DISCUSSIONS AND CLOSURES

Discussion of "Mechanics of Progressive Collapse: Learning from World Trade Center and Building Demolitions" by Zdeněk P. Bažant and Mathieu Verdure

Closure to "Mechanics of Progressive Collapse: Learning from World Trade Center and Building Demolitions" by Zdeněk P. Bažant and Mathieu Verdure

Fig. 1. Evolution of initial simultaneous crush up and crush down and its arrest within the first story being crushed

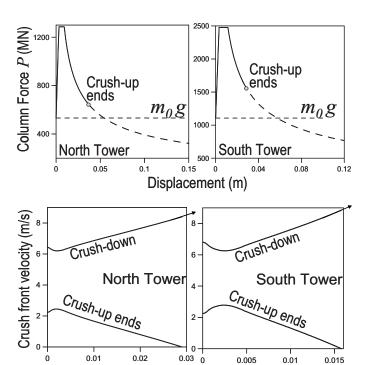
Fig. 1 shows the calculated evolution of displacement and velocity during the collapse of the first overlying story in two-way crush. The result is that the crush-up stops (i.e., $|\dot{x}|$ drops to zero) when the first overlying story is squashed by the distance of only about 1.0% of its original height for the North Tower, and only by about 0.7% for the South Tower (these values are about 11 or 8 times greater than the elastic limit of column deformation). Why is the distance smaller for the South Tower even though the falling upper part is much more massive? That is because the initial crush-up velocity is similar for both towers, whereas the columns are much stronger (in proportion to the weight carried).

The load-displacement diagram of the overlying story is qualitatively similar to the curve with unloading rebound sketched in Fig. (4c) of the paper and accurately plotted without rebound in Fig. 3 of the paper. The results of accurate computations are shown by the displacement and velocity evolutions in Fig. 1.

So it must be concluded that the simplifying hypothesis of one-way crushing (i.e., of absence of simultaneous crush-up), made in the original paper, was perfectly justified and caused only an imperceptible difference in the results. The crush-up simultaneous with the crush down is found to have advanced into the overlying story by only 37 mm for the North Tower and 26 mm for the South Tower. This means that the initial crush-up phase terminates when the axial displacement of columns is only about 10 times larger than their maximum elastic deformation. Hence, simplifying the analysis by neglecting the initial two-way crushing phase was correct and accurate.
